# Development Assessment Report

MC/13/133093

<b>DA #</b>	DA177/13
<b>Site Address</b>	Corner of Kenneth and Balgowlah Roads, Manly Lot 1 DP 168527 Lot 1 and Part Lot 3 DP 168526 Lots A and B DP 331109 Lots 36, 37, 43 to 54 inclusive and Lots 85 and 86 in Section 9 DP 939916
<b>Proposal</b>	Redevelopment of Manly Swim Centre Alterations and additions to the existing Andrew "Boy" Charlton Manly Swim Centre including partial demolition of existing facility structures, construction of an all purpose aquatic centre comprising of a twenty-five (25) metre eight (8) lane lap pool, seating for one hundred and fifty (150) spectators, program pool, leisure pool, spa pool, sauna and steam room, administration rooms, plant rooms, gymnasium and group fitness/multipurpose space, kiosk, amenities, with the retention of the outdoor 50 metre pool, outdoor toddlers pool, outdoor twenty-five 25 metre pool and plant rooms, on-site parking for 46 cars, 170 car parking spaces in Kenneth Road and a separate community facilities building containing change rooms, amenities, storage and a bus shelter

**Figure 7: Extract from Level 2 Plan showing structures proposed to be demolished.**

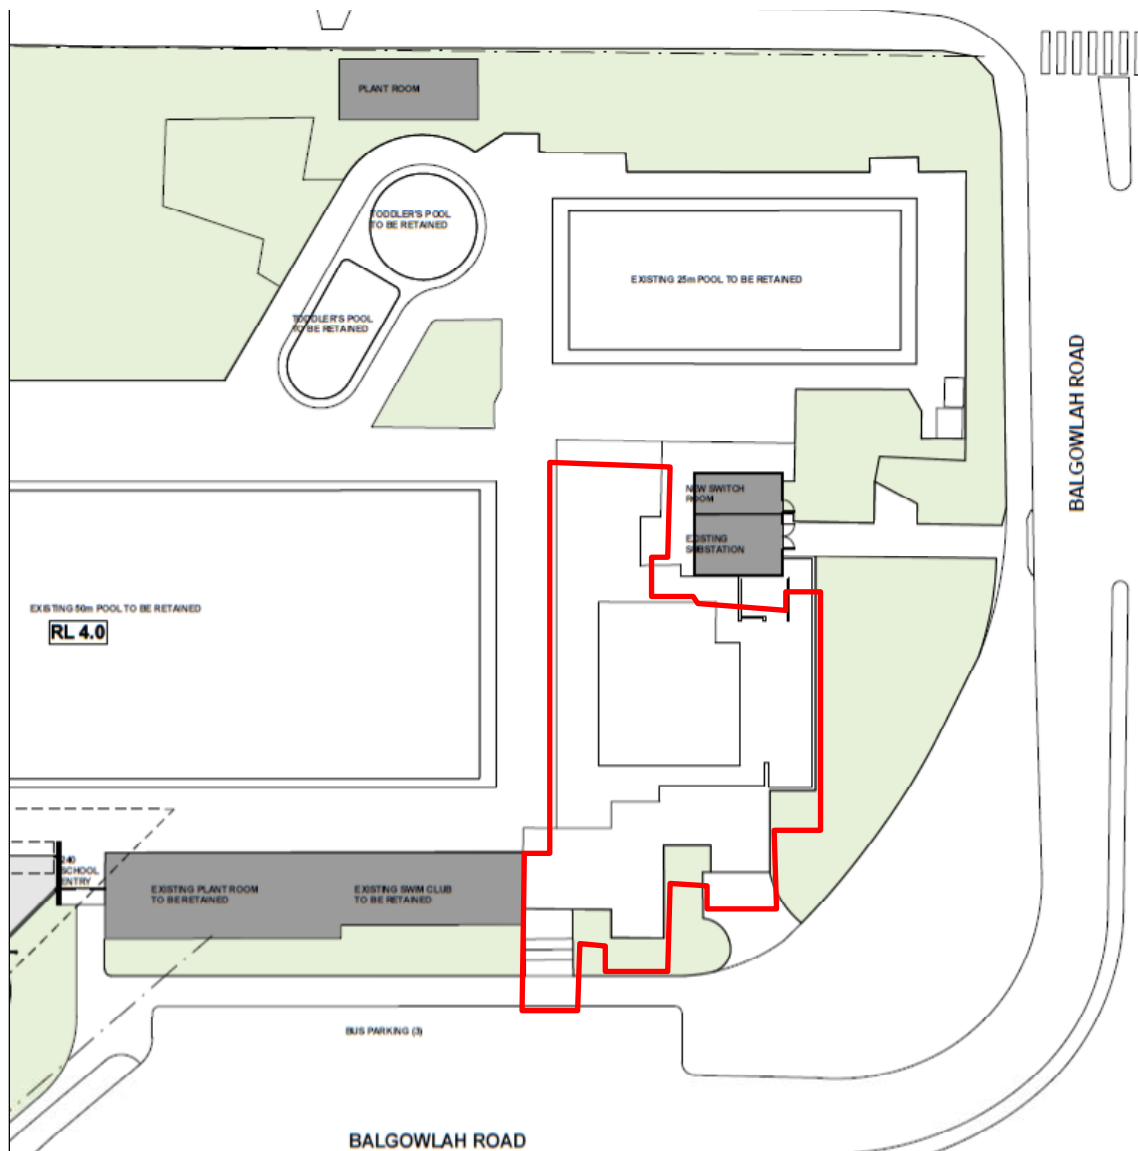
*Issue: Seek clarification of which buildings are to be demolished (not clear on plans).*

Assessment Comment: Figure 7 indicates the existing buildings proposed to be demolished as shown by red outline. Conditions of consent are recommended for additional toilet, change room and shower facilities be provided in conjunction with the swim club room to be retained to the south of the 50m pool.
